STATE OF NORTH CAROLINA  
DEPARTMENT OF TRANSPORTATION

March 24, 2023

**Subject: Request for Modification to Individual Section 404 Permit and Section 401 Water Quality Certification** for recently modified U-2579 AA (USACE, dated February 10, 2021; WQC Rev. 7, dated February 9, 2021), the Winston-Salem Northern Beltway (Eastern Section of Future I-74), from US 311 to I-40; U-2579AA; Federal Aid Project No. NHF-0918(14), Division 9. Debit \$570 from WBS No. 34839.1.7

**T.I.P. No: U-2579AA**

PERMIT DRAWING  
SHEET 7 OF 32

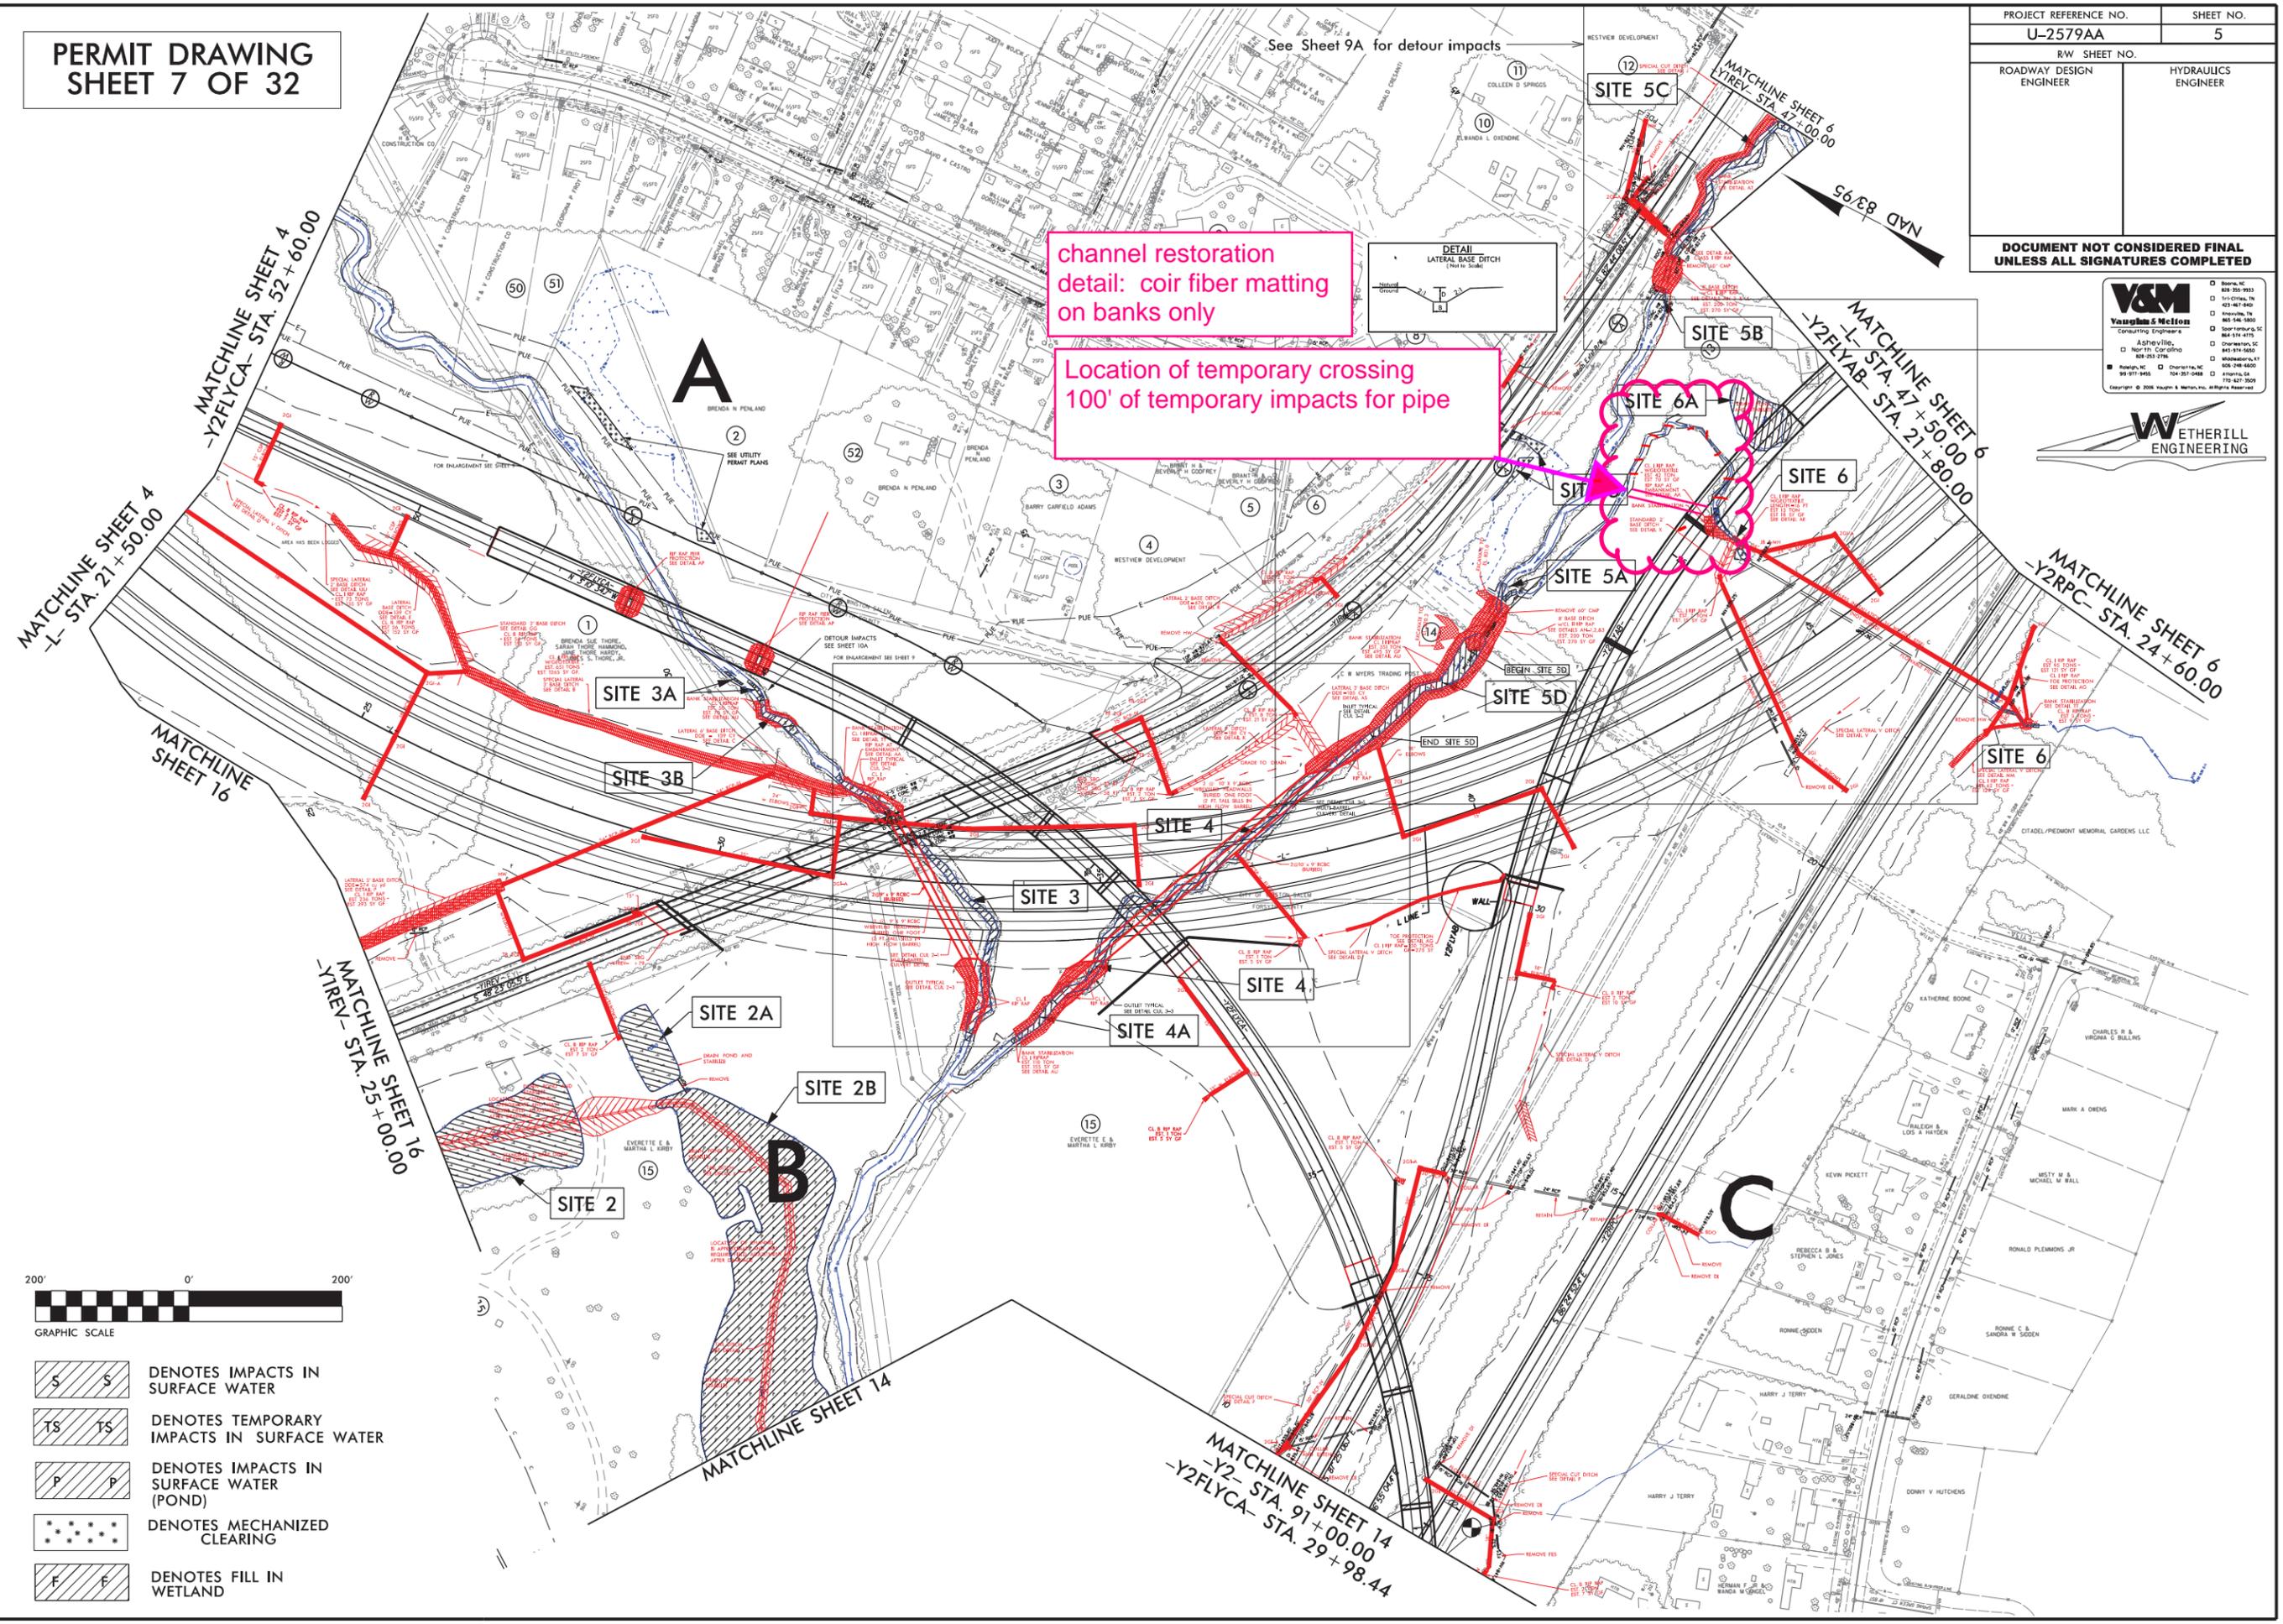
channel restoration  
detail: coir fiber matting  
on banks only

Location of temporary crossing  
100' of temporary impacts for pipe

Permit site 6: We have currently proposed 57' of permanent impacts from a welded steel pipe, 68' of permanent impacts from bank stabilization and 20' of temporary impacts. We need to propose an additional 100' of temporary impacts at this site. The stream, in its existing location, conflicts with the construction of the bridge piers. Installing the stream crossing will allow for the construction of the bridge piers and will provide better access to the site. It will also minimize the potential for unauthorized impacts to the stream from sedimentation due to the close proximity of the pier. The temporary crossing will be a 36" pipe that is 80' long. Due to the meander in the stream, the pipe is shorter than the impacts. The existing stream at this location has been field surveyed, so it can be restored in its existing location. Any impacted stream banks will be sloped at 2:1 or flatter, matted with coir fiber matting, and revegetated with native riparian seed mix
